OAKVILLE - THE BRANCH

WORK ORDER FOR SELECTIONS

1B + DEN	SUITE:	116
----------	--------	-----

SUBMITTAL BDP.
REVIEW Quadrangle

KITCHEN

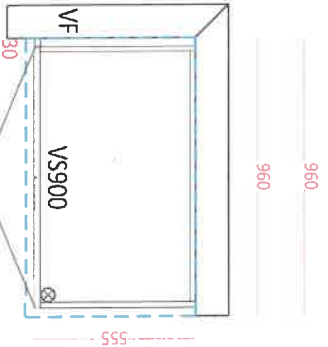
BDPQ: +/-3510. Please note that above dimensions are governed by the stair wall and exterior wall. Kitchen cabinets will have to be coordinated to fit within the provided space.

MAIN VANITY

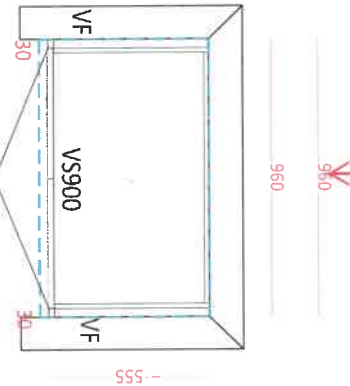
BDPQ: Site to ensure wall location is coordinated with vanity width.
